INITIAL APPRAISAL OF THE IMPACTS ON LYNDHURST
HALL OF THE PROPOSED BASEMENT CONSTRUCTION AT
11 ROSSLYN HILL, NW3

Prepared for
Richard Boote

Project no.
1580

Date
27 May 2015

SK. B SKETCH SECTION SHOWING PROPOSED UNDERGROUND SWIMMING SHOWN ADJACENT TO AIR STUDIOS MAIN HALL
~1:100 @ A3

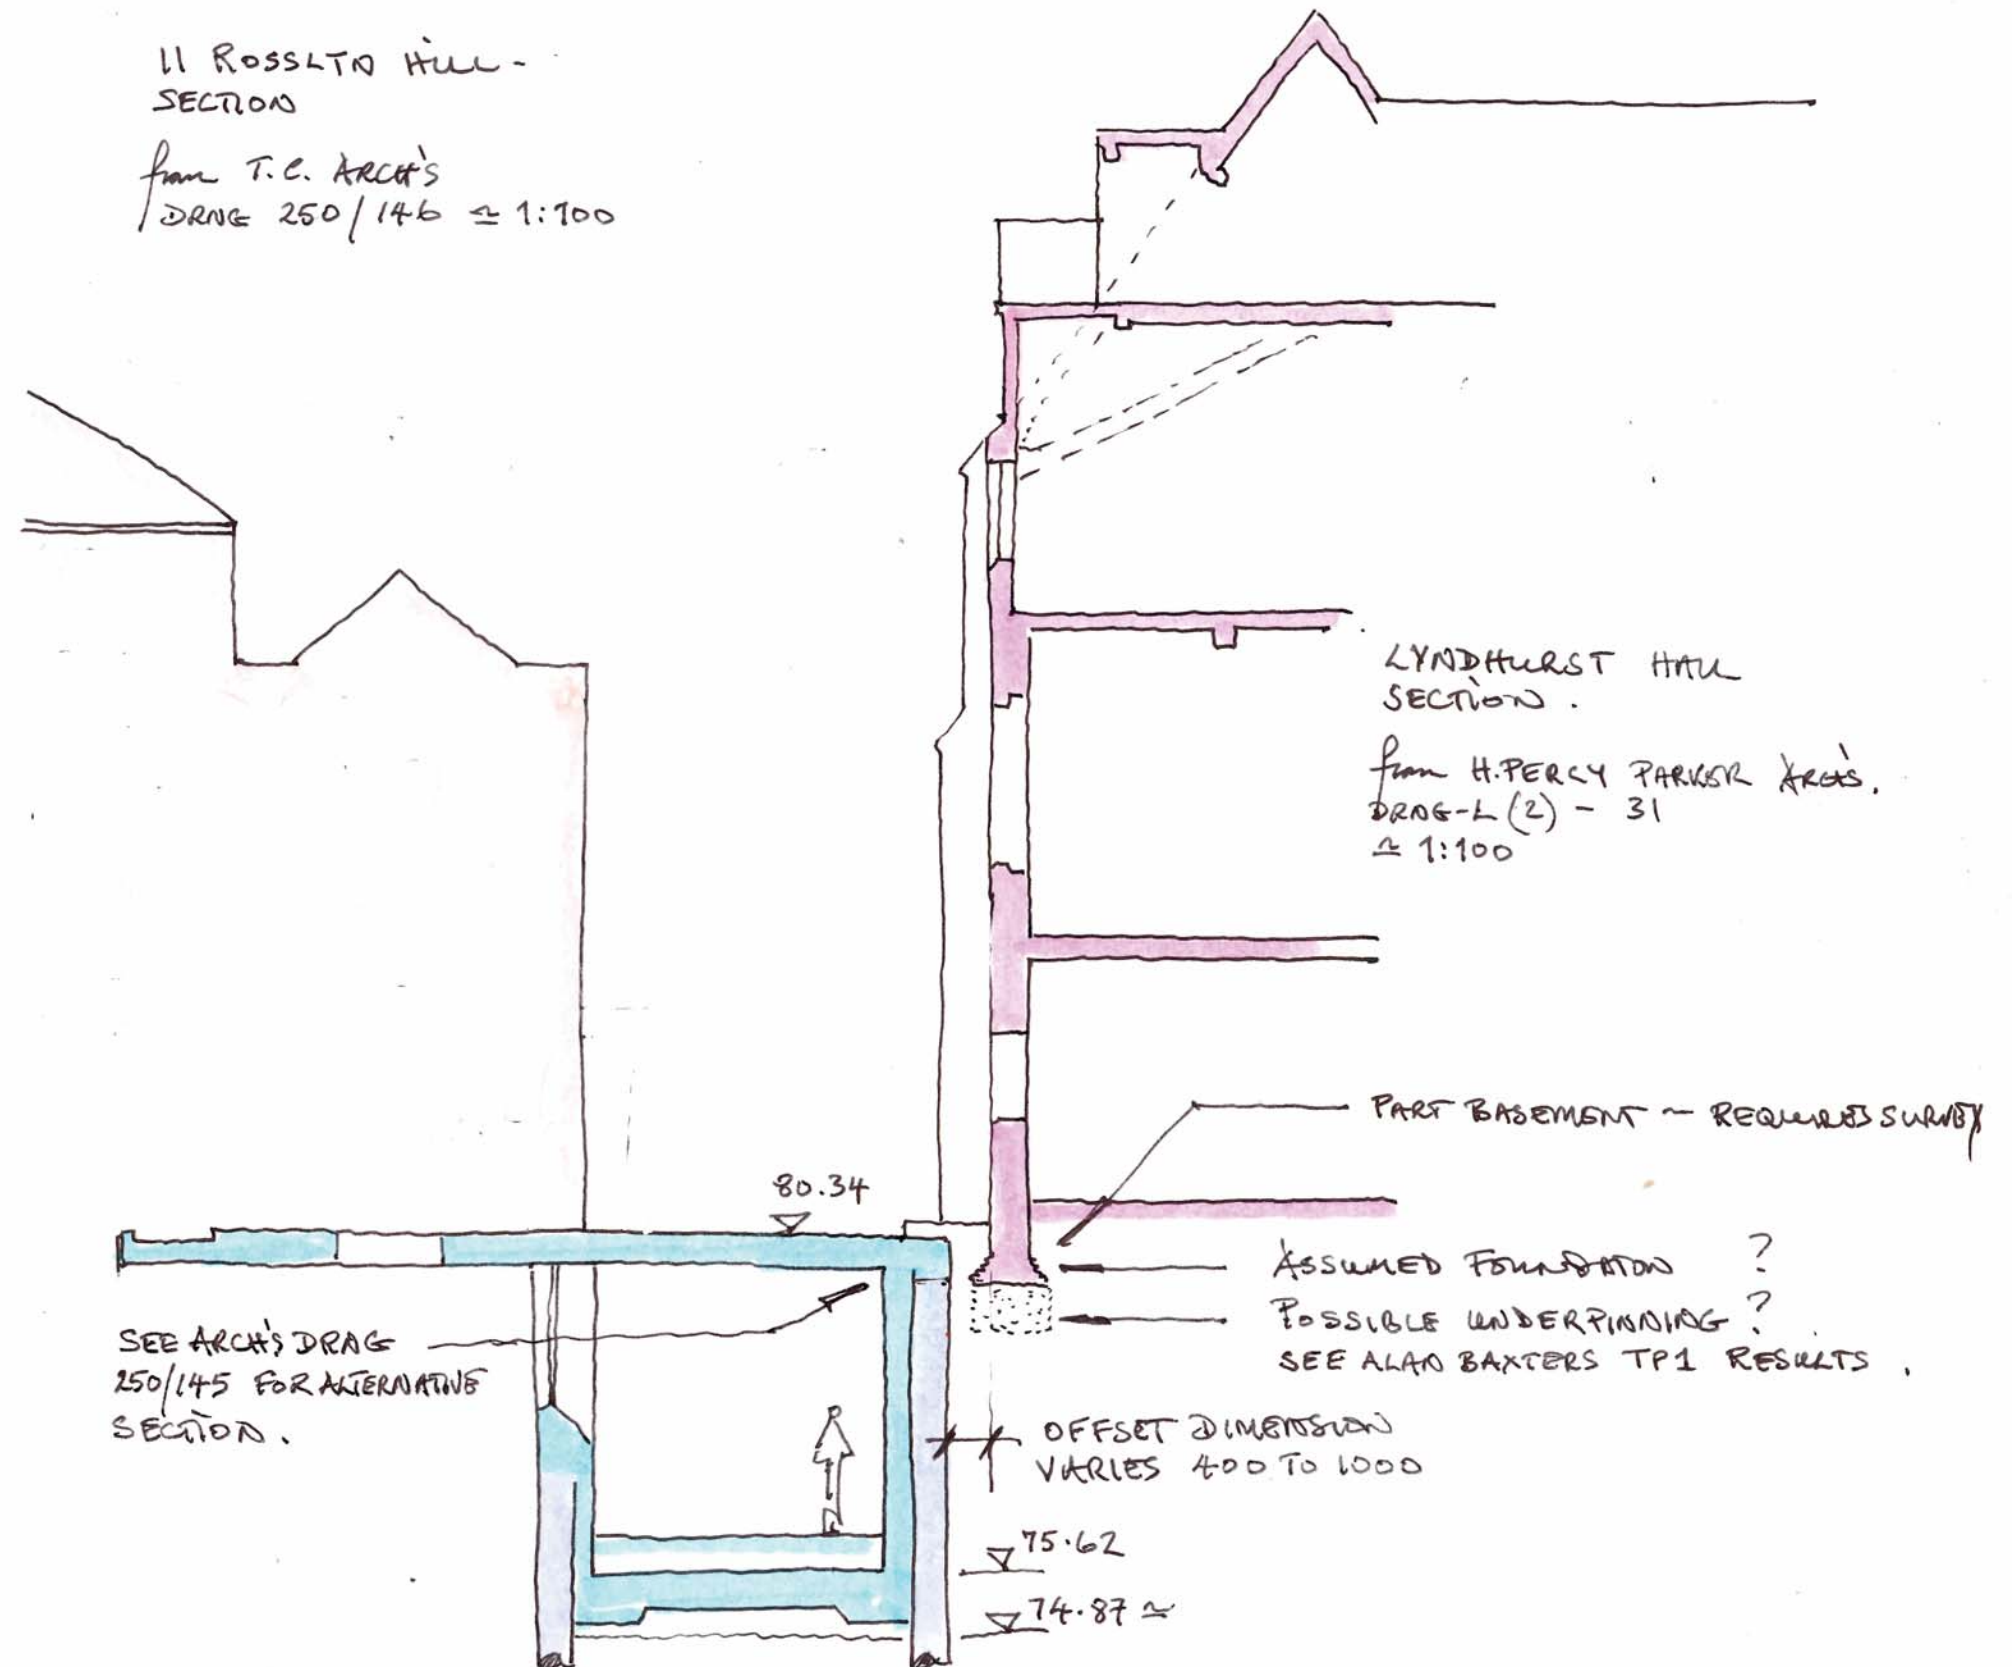
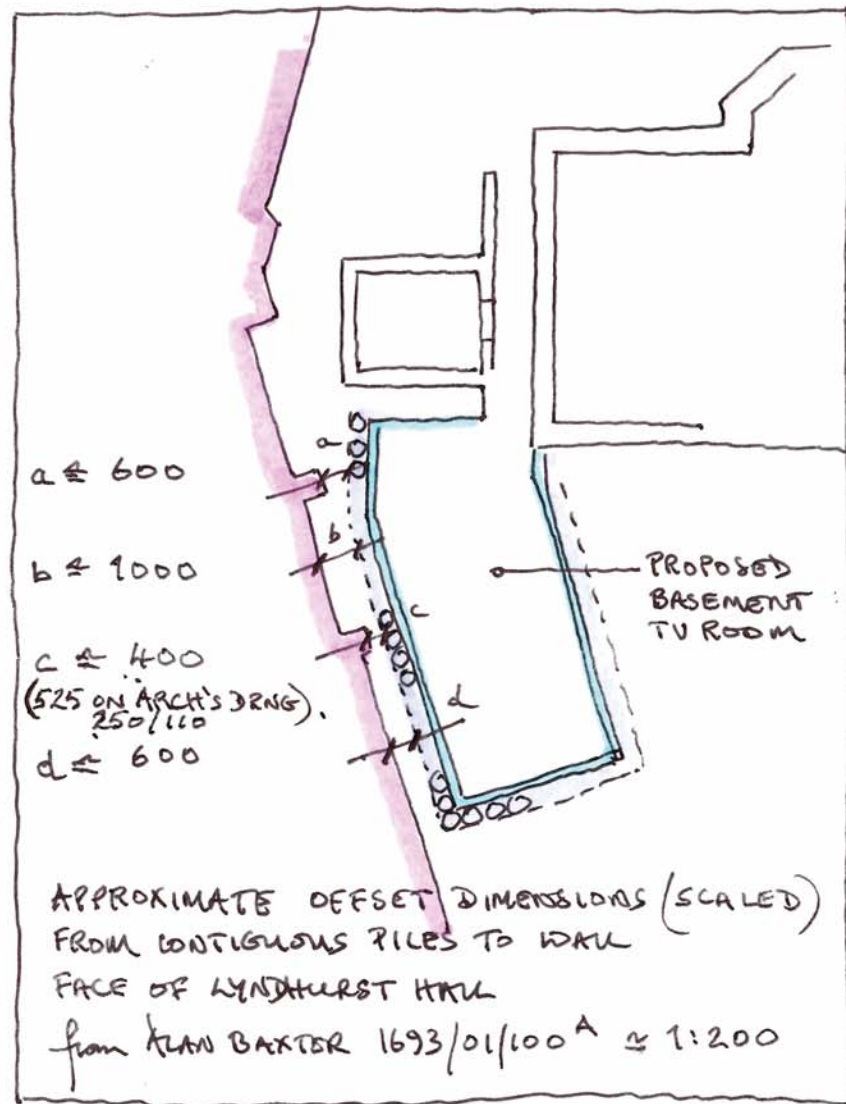
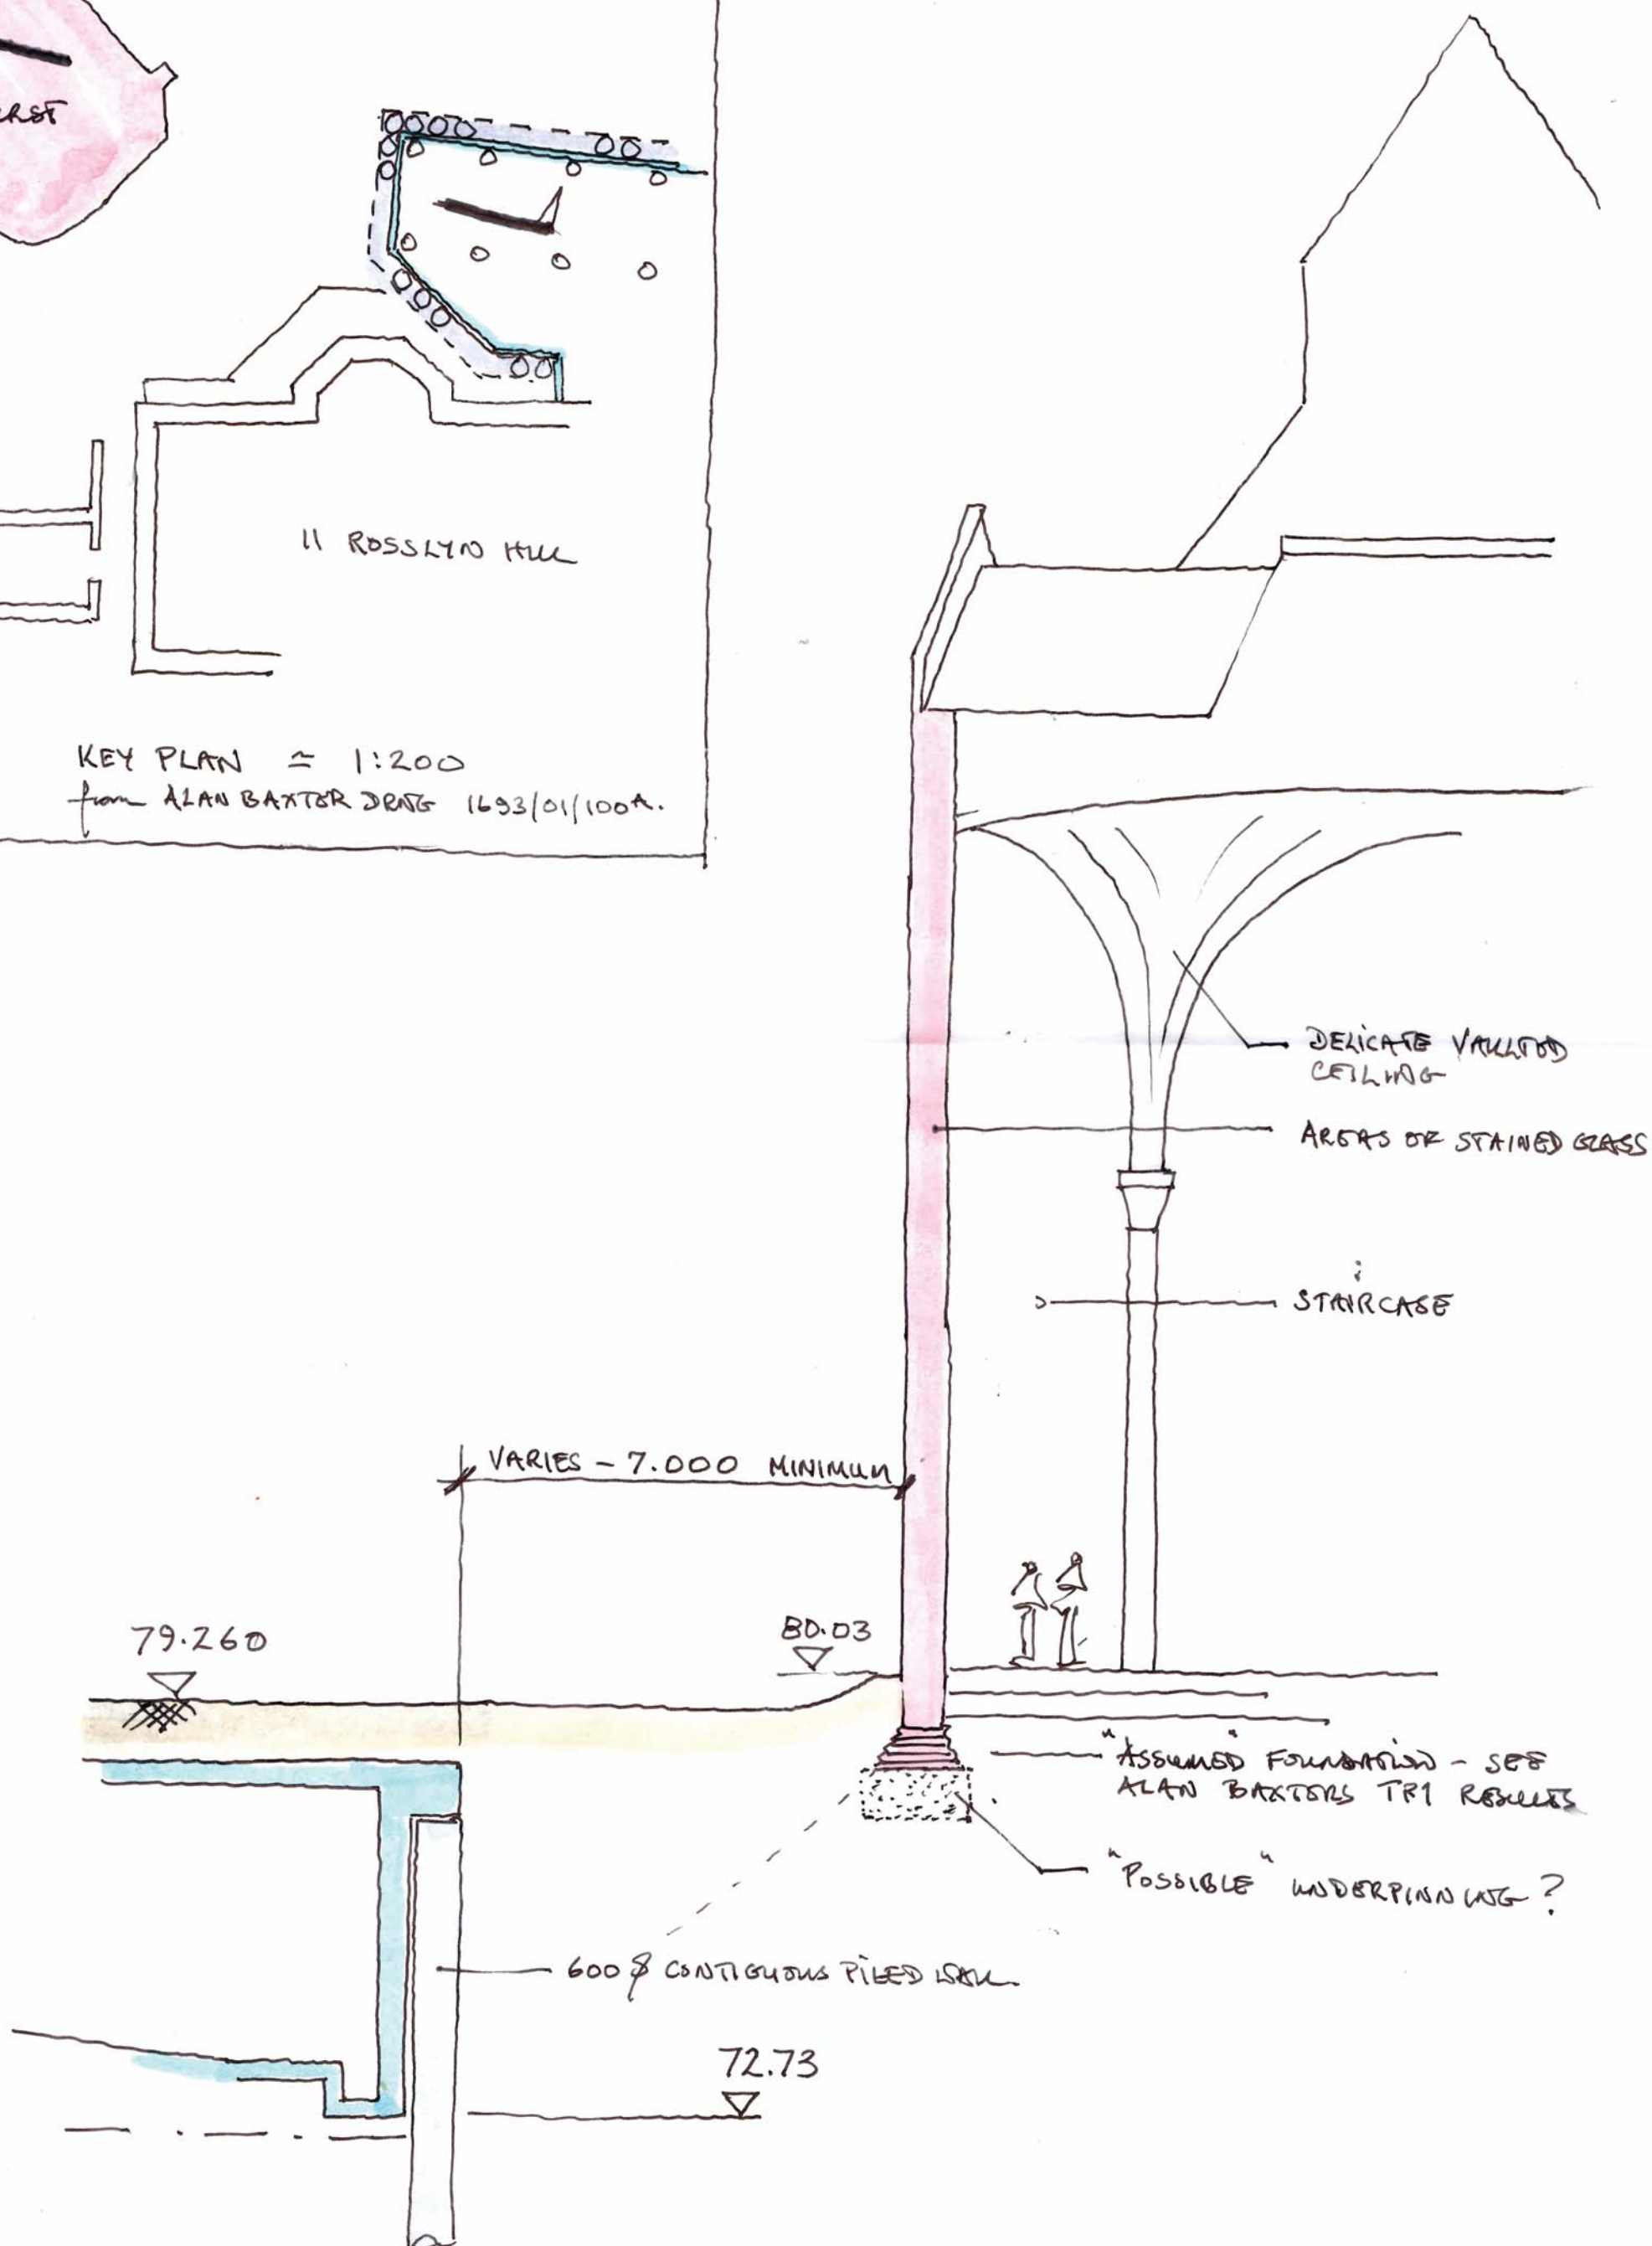
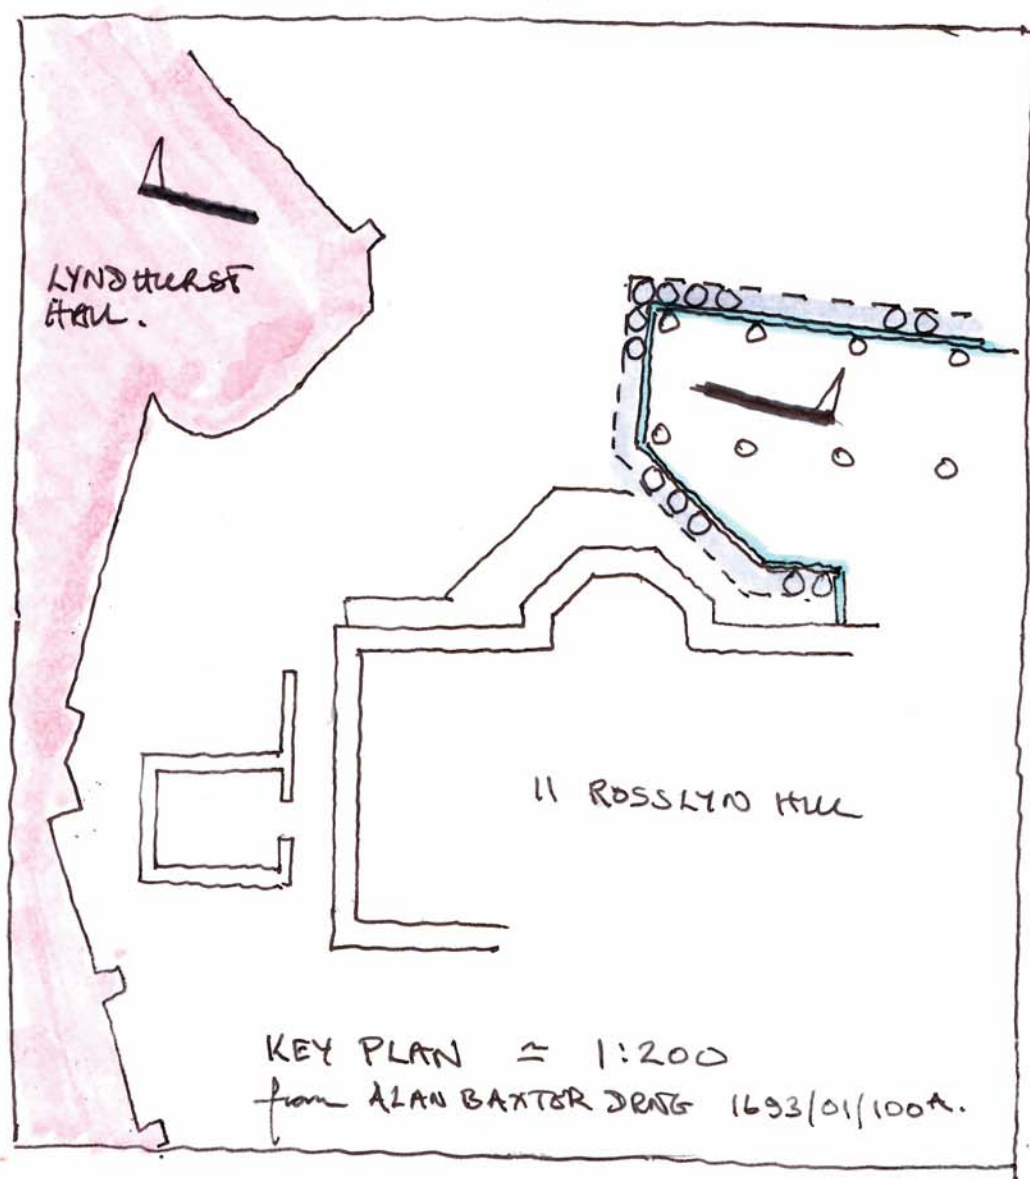
We have sketched out some approximate sections through Lyndhurst Hall and the proposed basements which begin to investigate and demonstrate the effects of the basement construction on the Hall, as well as highlight some potential issues that the Hall's presence may have on the setting out, design and construction of the basements. These are included in Appendix A of this report.
